MILITARY SPECIFICATION SHEET

CONNECTORS, ELECTRICAL, RECTANGULAR,
RACK AND PANEL, SOLDER TYPE SOCKET CONTACTS, SIZE 22

This amendment forms a part of MIL-C-28748/8E, dated 1 April 1993, and is approved for use by all Departments and Agencies of the Department of Defense.

MIL-C-28748/8E
AMENDMENT 3

*FIGURE 3, configuration G, delete and substitute as follows:

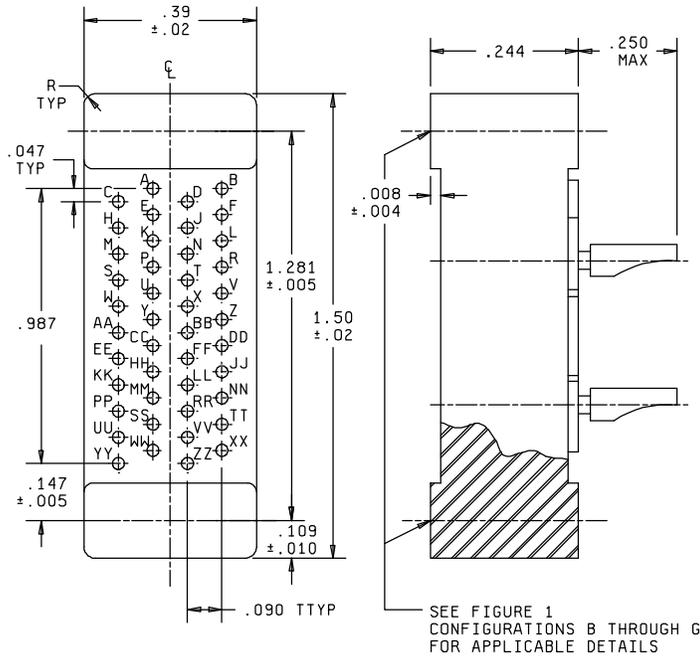
Insert with 44 contacts
